# CITY COUNCIL ACTION FORM

Public Hearing and Second Reading for **Ordinance 2022-06**: An Ordinance of the City Council of the City of Salida Approving a Major Impact Review for a 0.60 Acre Parcel Located at 323 West First Street Currently Zoned Commercial (C-1) and Industrial (I) and Within the Hwy 291 Established Residential Overlay, to Place a Planned Development Overlay on the Property and Approve the Development Plan and 16-Lot Major Subdivision for Residences at Salida Bottling Company.

The applicant is requesting a Major Impact Review to approve a Planned Development overlay and a 16-lot subdivision on the 0.60 ac. parcel at 323 West First Street, located at the west corner of Hwy 291 and the Monarch Spur Trail (see vicinity map below). The property is currently split-zoned C-1 and I and within the Hwy 291 Established Residential Overlay. The property owner is Salida Bottling Company, LLC represented by Eric Warner.

**Units 1-4** Units 1-4 are proposed at the allowed 2 stories for the majority of the structures. A deviation was requested for Units 1-4 to locate a rooftop access structure on each, limited to 100 sf per unit, with a maximum height of 40 feet to the highest point of the structure.

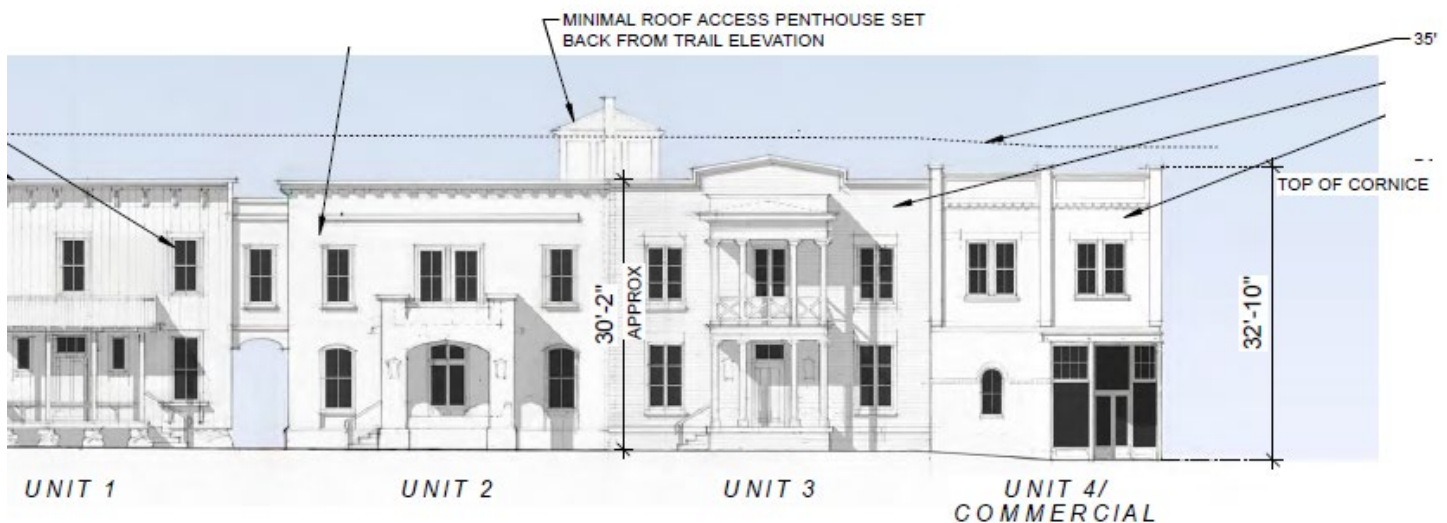
Staff recommended that the request be limited to the minimum necessary to allow rooftop access and only where it will not potentially obstruct prominent view corridors from downtown. Therefore the following limitations were recommended: rooftop access on Units 2 & 3 be allowed only as one combined structure at a total of 150 sf and that no rooftop access structure be allowed on Unit 4 due to the higher visibility of that location from downtown and the potential obstruction of prominent viewsheds.

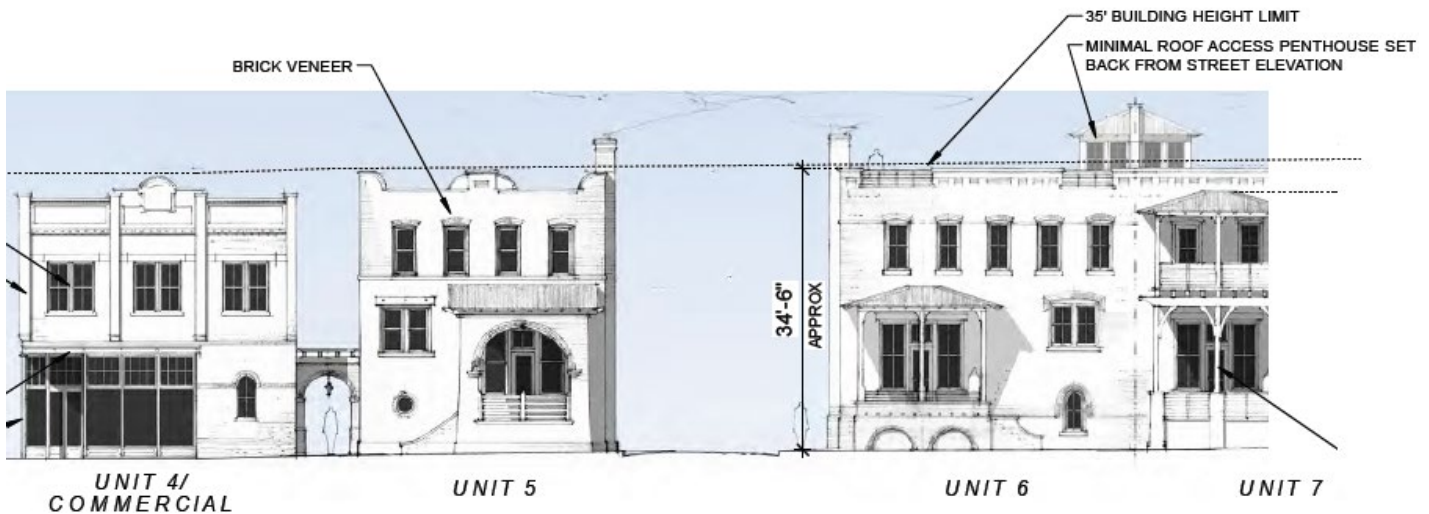
**Units 5- 7** (in blue on the site plan). The applicant is requesting a deviation to allow Units 5-7 to be 3 story buildings. The proposed maximum height of the 3 stories is 35 feet, which does not require a deviation. However, a deviation is requested to allow a rooftop access structure, limited to 100 sf per unit, to be a maximum of 40 feet at its highest point. Additionally, the applicant has requested an allowance for chimneys up to 40 feet.

*(see building cross-section to right illustrating proposed rooftop access structure and chimney height)*

The request for 3 stories along 1<sup>st</sup> Street will accommodate the proposed historically-referenced architectural design that is unique for new construction. It is a design that, when viewing from 1<sup>st</sup> & F Street, reads as an extension of the historic downtown. The primary structure will be a maximum of 35 feet in height, which is allowed in the Overlay District. Therefore staff supports the request for 3 stories. Staff recommends that the rooftop access request be limited to the minimum necessary and only where it will not potentially obstruct prominent view corridors from downtown. For this reason, staff recommended that no rooftop access structure be allowed on Unit 5 and that rooftop access on Units 6 & 7 be allowed only as one combined structure at a total of 150 sf. This was a condition of approval from Planning Commission and the applicant has agreed and incorporated it into the PD Plan.
